# SERVICE BULLETIN

No. 759

Piper Aircraft Corporation

Subject: Exhaust muffler inspection and modification,  
Piper Part Number 12433-00, 12433-14,  
12232-00.

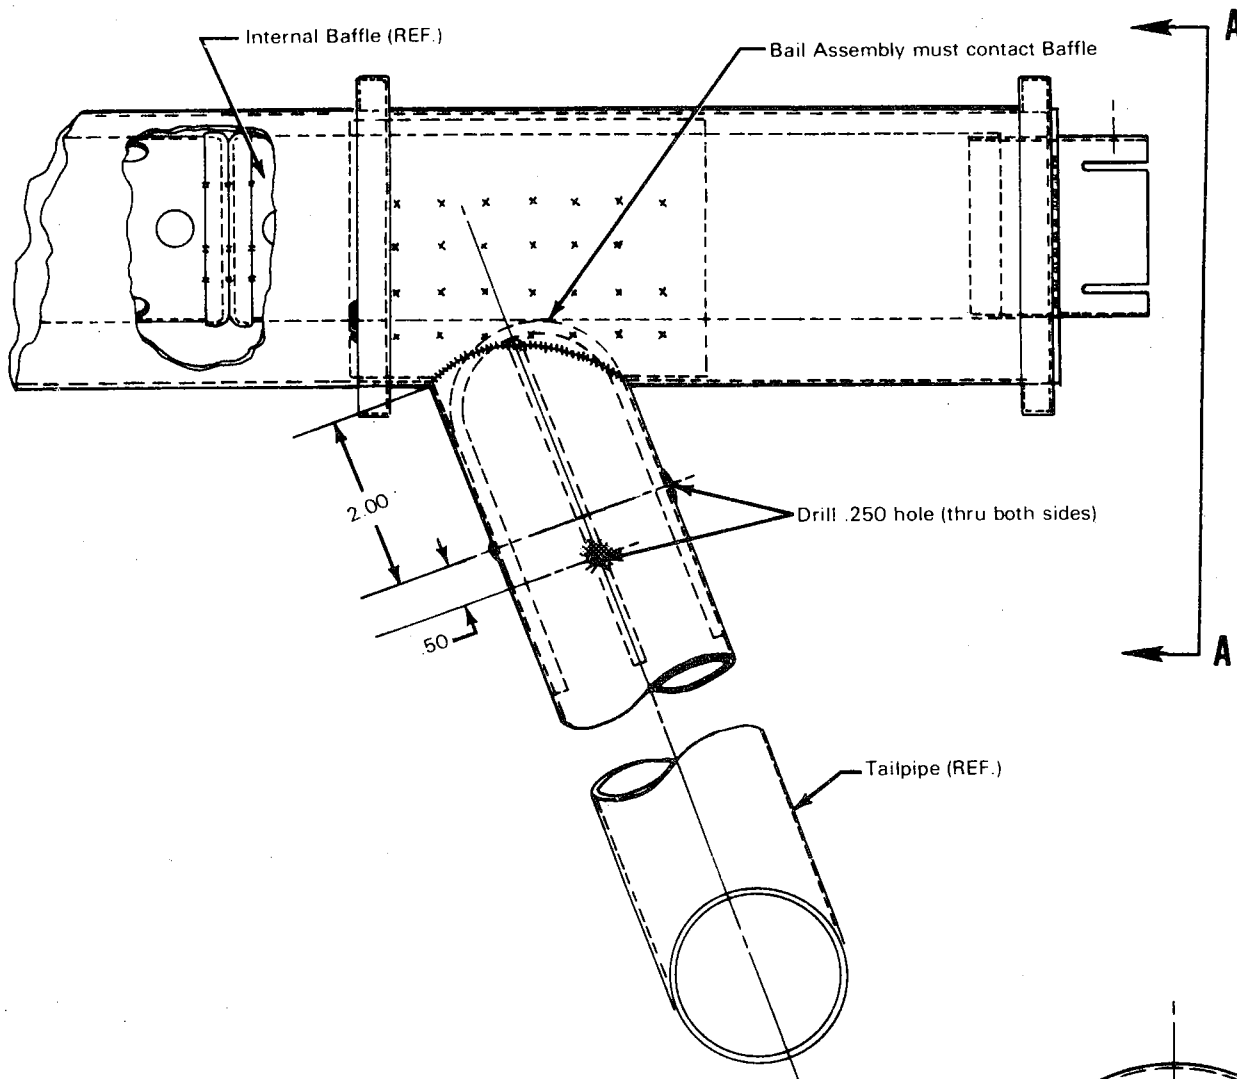
7. Remove shroud from muffler assembly and comply with AD 68-05-01.
8. Drill two 1/4 inch (.250) holes through the tailpipe as shown in the following sketch.
9. Install bale assembly, Piper Part Number 452 093 into tailpipe, curved end toward the muffler until contact is made with the internal baffle. The deflector must be installed so that the opposing legs cover the four holes that have been previously drilled.

Note: A 3/4 inch square x 18 inch long stick of wood or 3/4 inch diameter x 18 inch long metal tube may be fabricated into a special tool to twist the deflector if necessary after installation to locate two of the legs directly inside the 1/8 inch holes in the tailpipe. (See sketch).

10. Rosette weld by suitable method the bale through the four 1/4 inch holes in tailpipe.
11. Reassemble muffler assembly and reinstall on aircraft. Install exhaust system components and reconnect any lines, wire, and hoses that were removed. Attach engine properly and reinstall engine cowling that was removed.
12. Make appropriate log book entry stating compliance of this Service Release.
